Project: IEEE P802.15 Working Group for Wireless Personal Area Networks (WPANs)

Submission Title: Contribution for CSK Related Comments

Abstract: Remedies for CSK related comments, Comments 312, 474, 475, 489, 496, and 512 are suggested for the 15.7 standard.

CURRENT CONSTELLATION IN D1

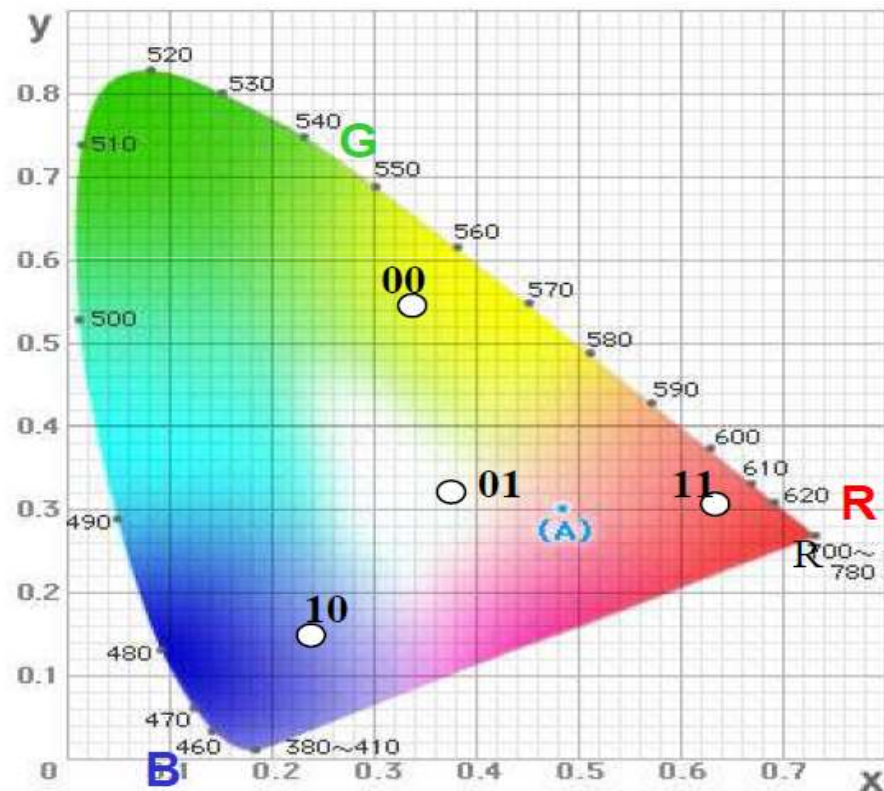
- Problem with this constellation
 - Points of light sources should be outside of the constellation.
 - Some light sources can be located inside the constellation.
 - For this case, light signals for corresponding constellation points can not be generated.
 - Constellation and formulae in the above should be modified.

MODIFIED CONSTELLATION

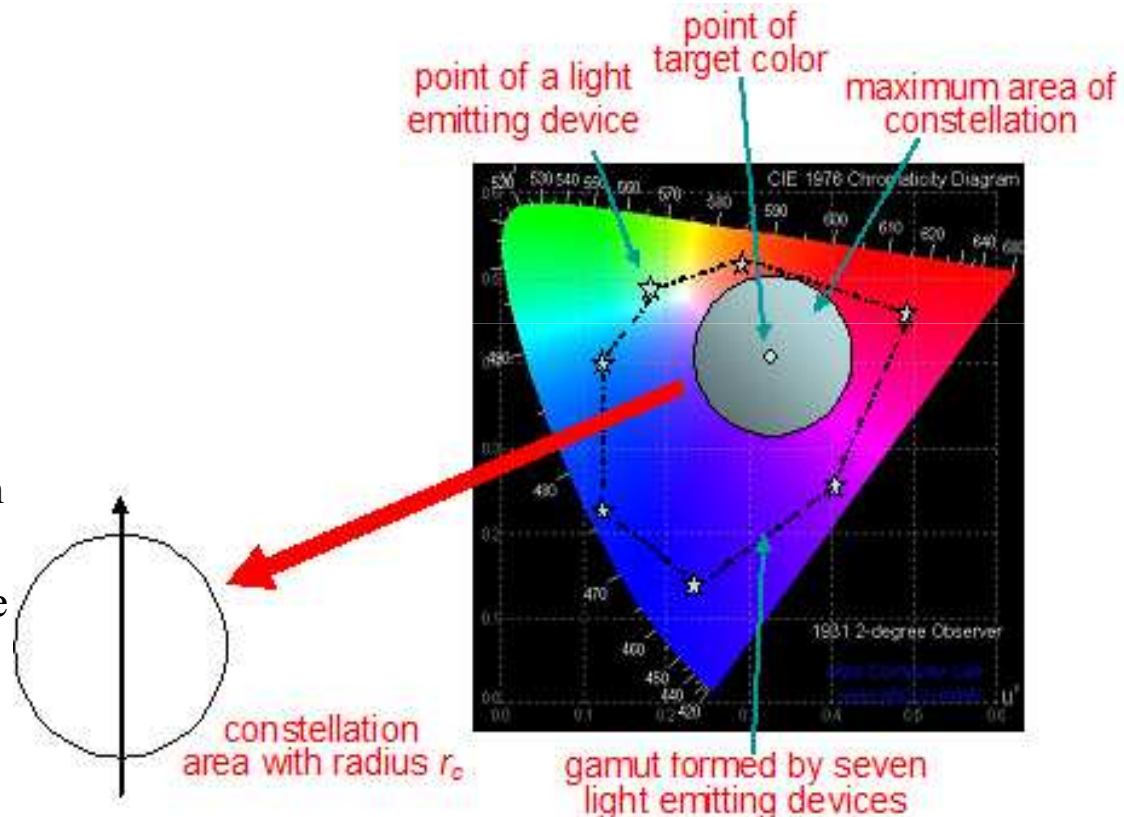
- Formation of a maximum constellation area
 - Light sources determine the gamut area.
 - Depending on the target color
 - A specific target color can be generated.
 - Current constellation is one with white target color and three light sources.
- More flexibility
 - Any target color
 - Any number of light sources

SYMBOL POINT DISPERSION (1)

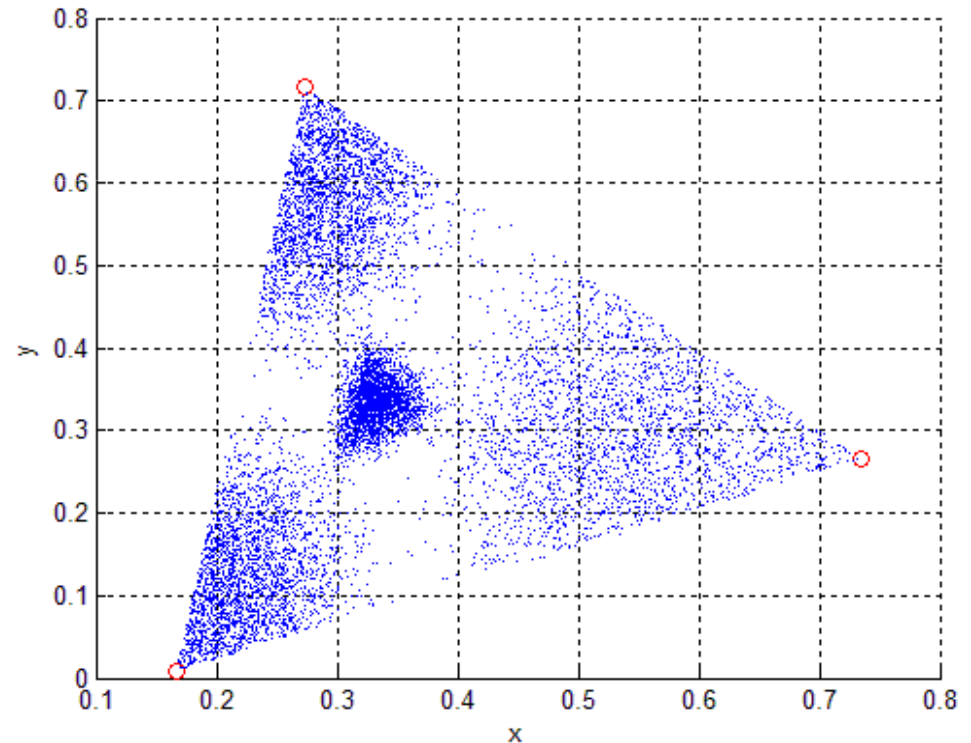
- Dispersion of received symbols for CSK due to added AWGN noise on CIE 1931 with current formulae
 - Each symbol has a different dispersion area depending on the location of the point.

SYMBOL POINT DISPERSION (2)

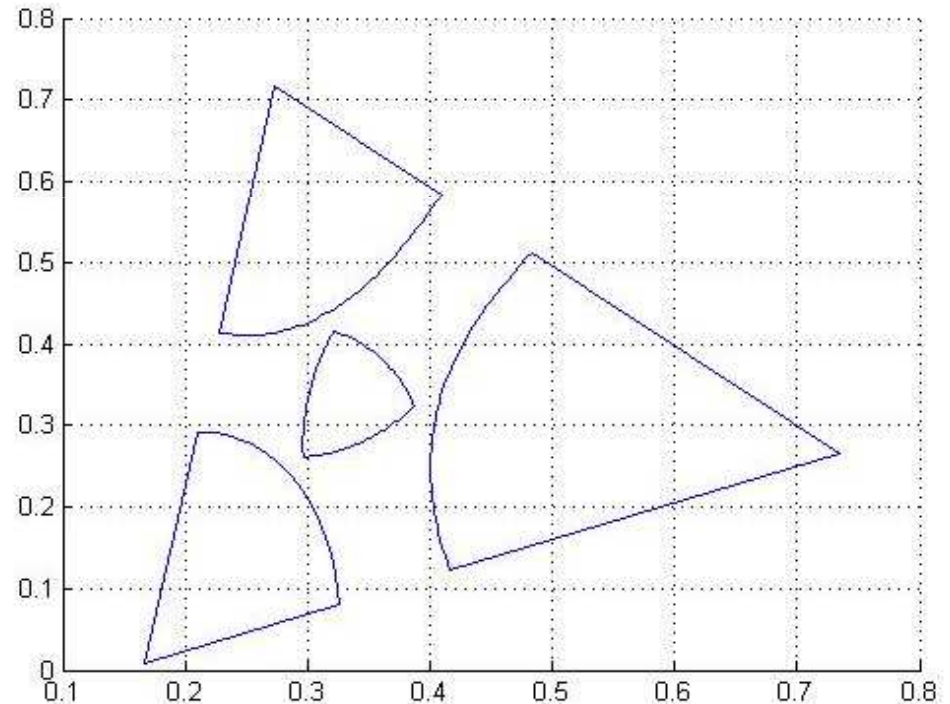
- Subareas each of which represents its own symbol due to added AWGN noise on CIE 1931 with current formulae
 - Each symbol has a different dispersion area depending on the location of the point.

SYMBOL POINT DISPERSION (3)

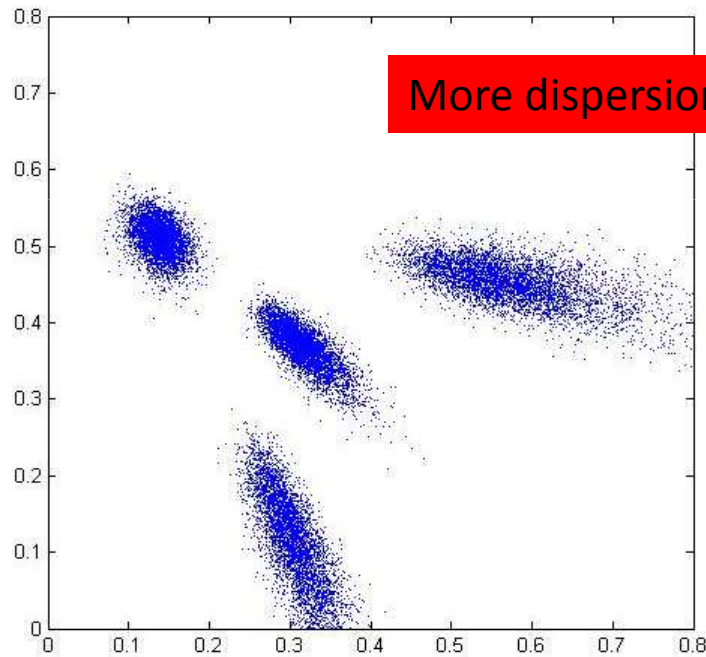
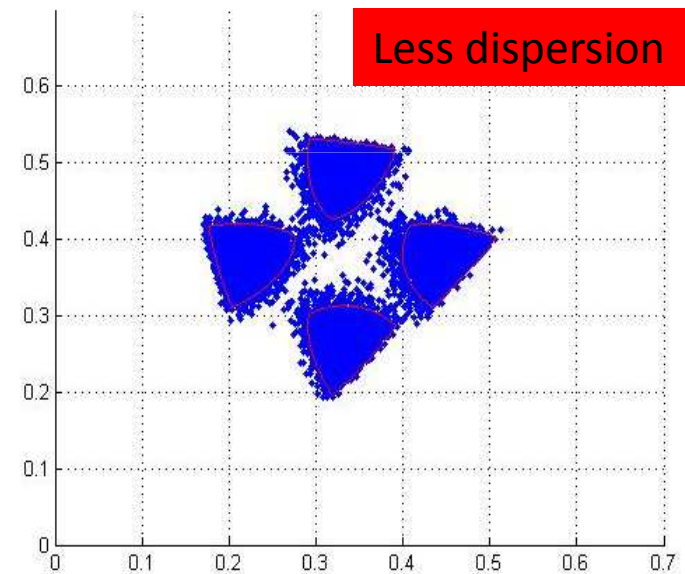
- Dispersion of received symbols for CSK which results in degradation of performance on CIE 1976

PERFORMANCE COMPARISON

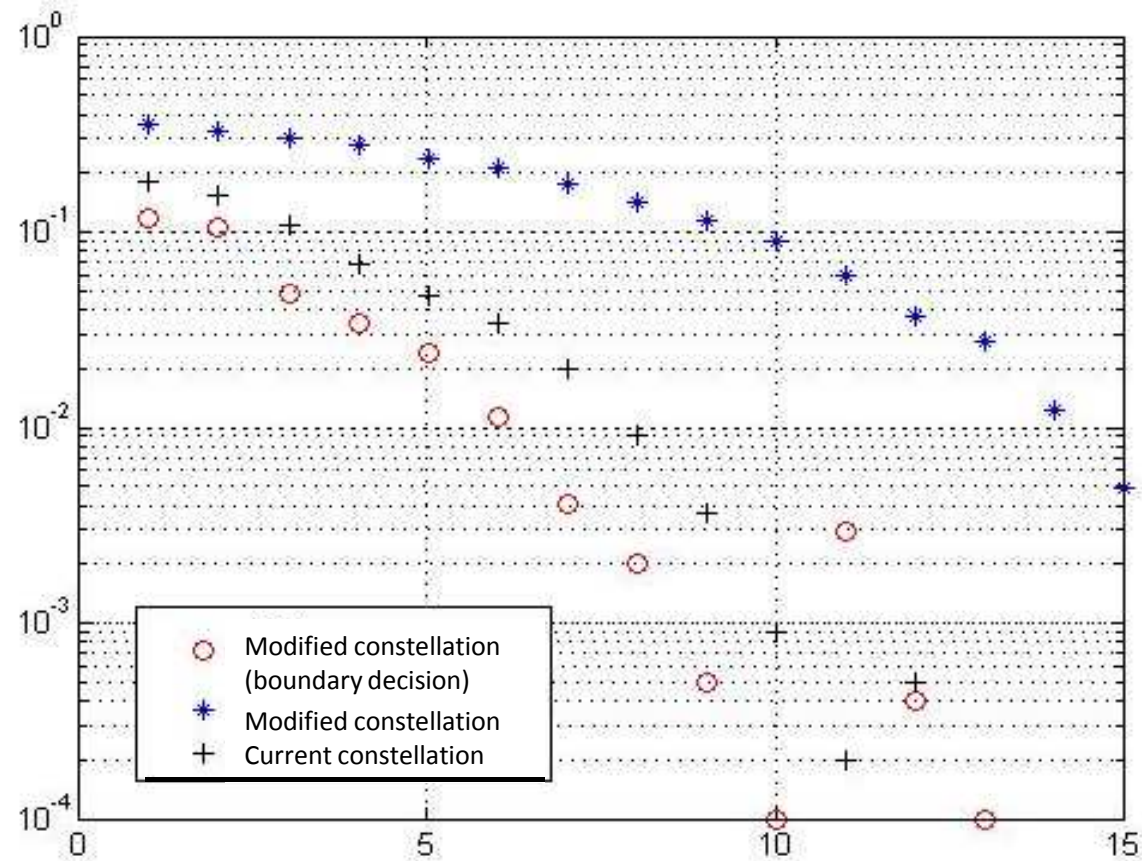
- BER performance comparison between current constellation and modified constellation

Figure 39—Color constellations for CSK

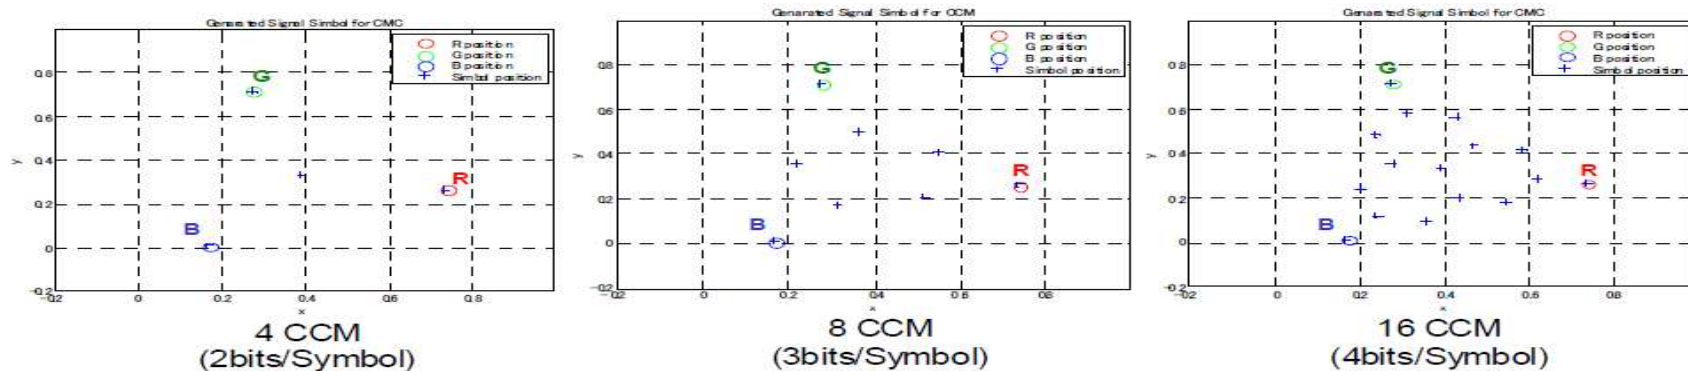
- Comment 475: 6.8.5 Page 55 Line 21 & Comment 512: 6.8.6.2 Page 59 Line 22
 - “CSK's constellation can be optimized with the characteristics light sources used. Therefore better constellation can be used for better performance for CSK.”
- Suggested Remedy
 - Better constellations depending on the symbol sizes should be used for better performance. **Apply the modified constellation and corresponding mapping formulae described in one of previous slides.**

Figure 41—CIE 1931 xy color coordinate

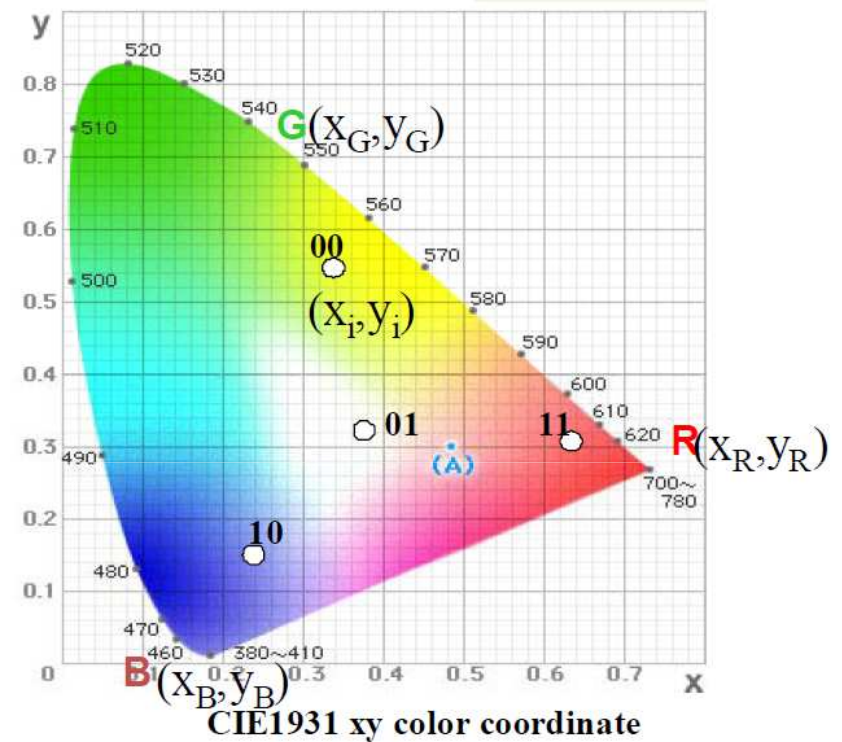
- Clause and Page : **6.8.6 Symbol to Optical Mapping**
- Comment 489: 6.8.6 Page 56 Line 25
 - “Same issue as for Section 6.8.5. CSK's constellation can be optimized with the characteristics light sources used. Therefore better constellation can be applied for better performance for CSK.”
- Suggested Remedy
 - Better constellations depending on the symbol sizes should be used for better performance. **Apply the modified constellation and corresponding mapping formulae described in one of previous slides.**
